# Access Compliance Report

## Public Rights-of-Way

### (Curb Ramps)

| Intersection ID: 10273                  | Main Street: SWEETBRIAR_ST | Cross Street: THE_PLAZA                 | Location: SW           |

| ADA ID: D9C144D2A40C                    | Ramp Type: Para            | Initial Pass/Fail: Pass                 | Overall Compliance: No |

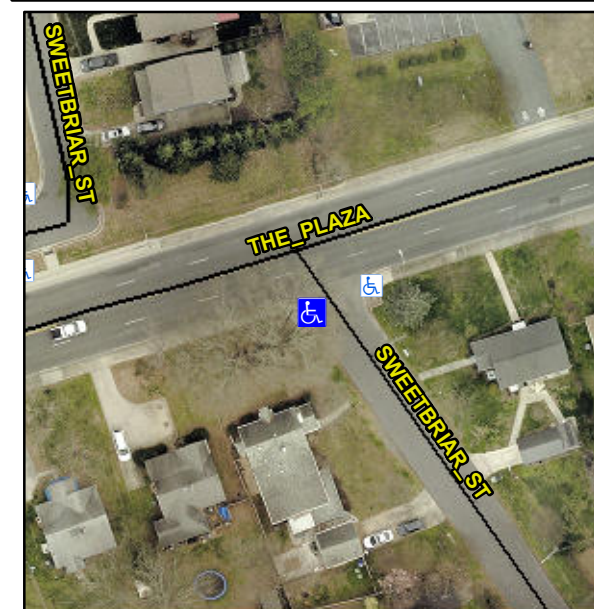
Possible Solutions:

**Remove & Replace Entire Ramp.**

PROW/ADA:

**R305.2**

| Compliance | Description          | Data | Compliance | Description                 | Data |
|------------|----------------------|------|------------|-----------------------------|------|
| N/A        | Landing Curb? (Y/N)  | Yes  | No         | DWS Offset (in)             | 2.5  |
